# Reply to reviewers comments for the UWO open dataset

ESSD-2024-47 | Data description paper

The UWO dataset – long-term observations from a full-scale field laboratory to better understand urban hydrology at small spatio-temporal scales

## Response to Reviewer #1 (Agnethe Nedergaard Pedersen)

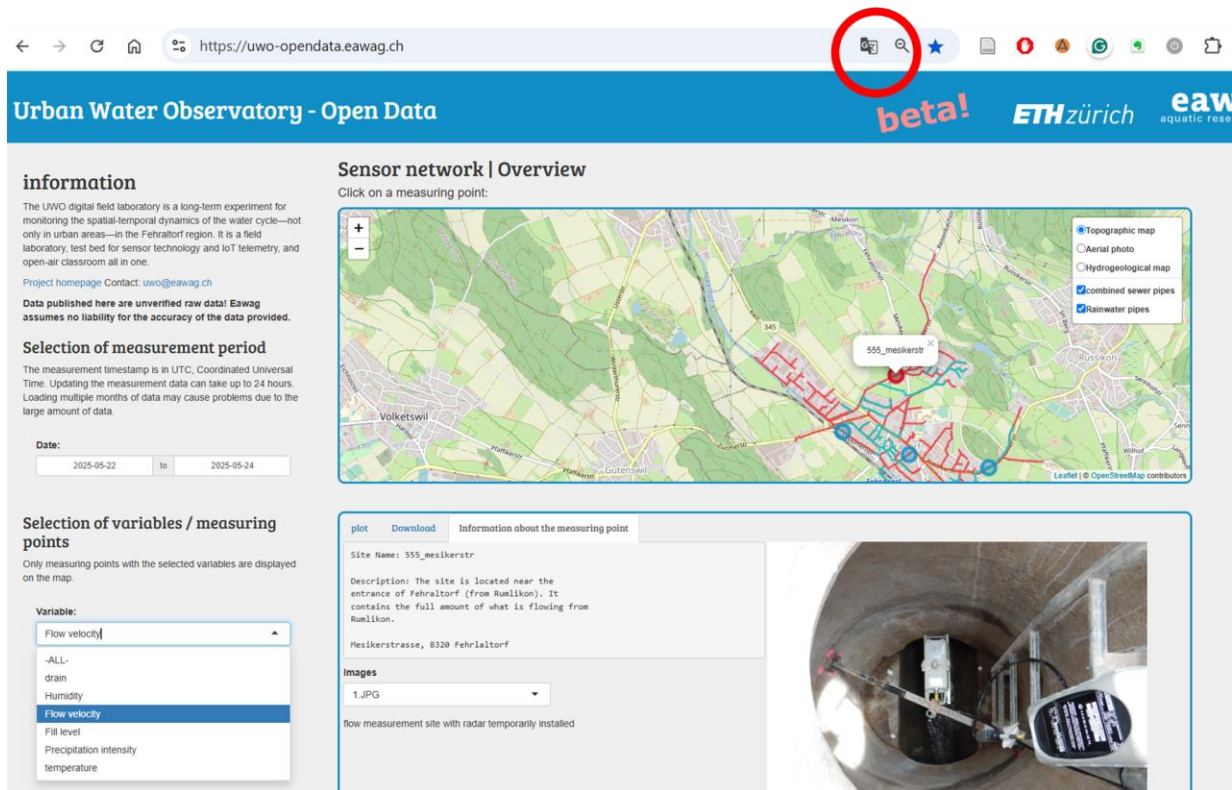
Thank you for a very well written and descriptive paper of the UWO dataset. **The submission describes a three year long comprehensive measuring campaign of the urban drainage system in a Swiss minor city along with an accompanying SWMM model. The dataset is unique and well described in the manuscript with thorough supplementary material. The manuscript highlights well-thought potential application areas of the dataset.** Dataset is made accessible and with a link to a data viewer. **Translating this viewer would be of high value for the future users not able to read Swiss.** The data structure of the SQL databases are well structured and it is easy to understand data.

We appreciate the positive evaluation. Language should not be a barrier, because browsers like Google Chrome, Firefox, Edge and Safari offer translation features, either as built-in features or through extensions (red circle).

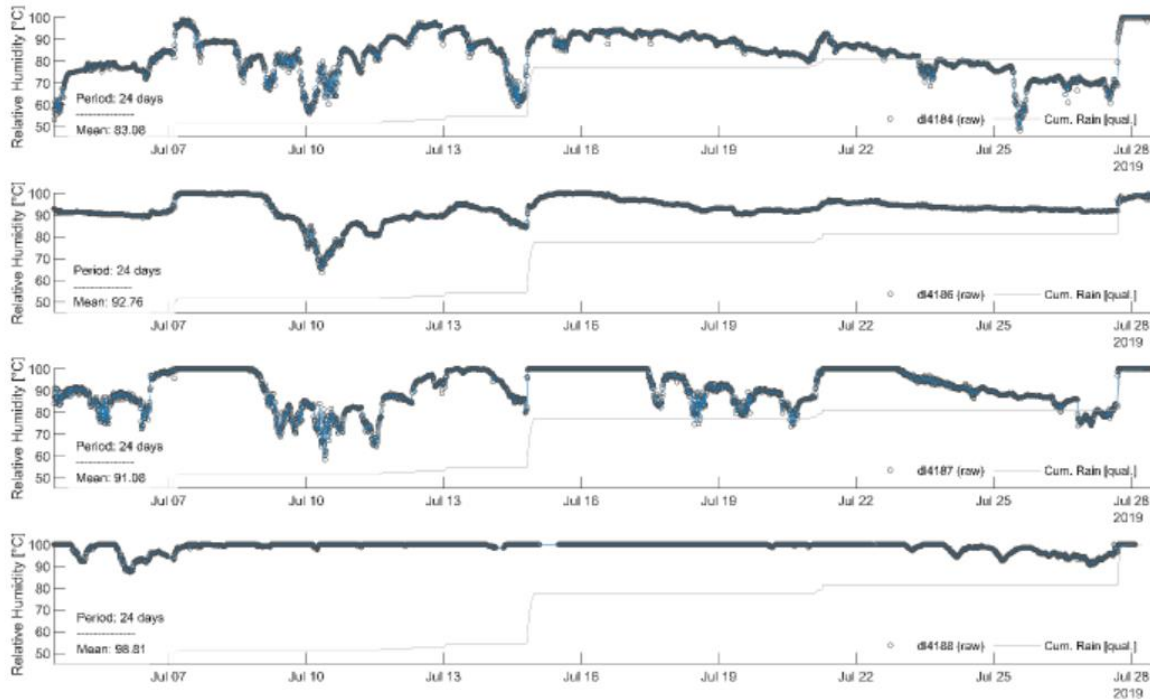
32. L487: In Figure 10, only the temperature is shown and it remains unclear, how the author determines if there is a real evaporation or condensation. From my understanding, the humidity is an important factor affecting these processes. Additionally, it is unclear, what medium evaporates or condensate.

a) As shown in Figure 2 (Figueroa SI, see below), we measured relative humidity (RH) in the sewer headspace at four locations in the Urban Water Observatory (UWO). The observations show that RH typically ranges from 83% to 98%, but only rarely reaches full saturation (100%)—even during humid summer conditions. This suggests that net latent heat fluxes (evaporation or condensation) are indeed possible under real operating conditions.

**We treated the relative humidity as stationary with a fixed value of 91.4%, which corresponds to the mean RH across the observed locations in the above Figure.**
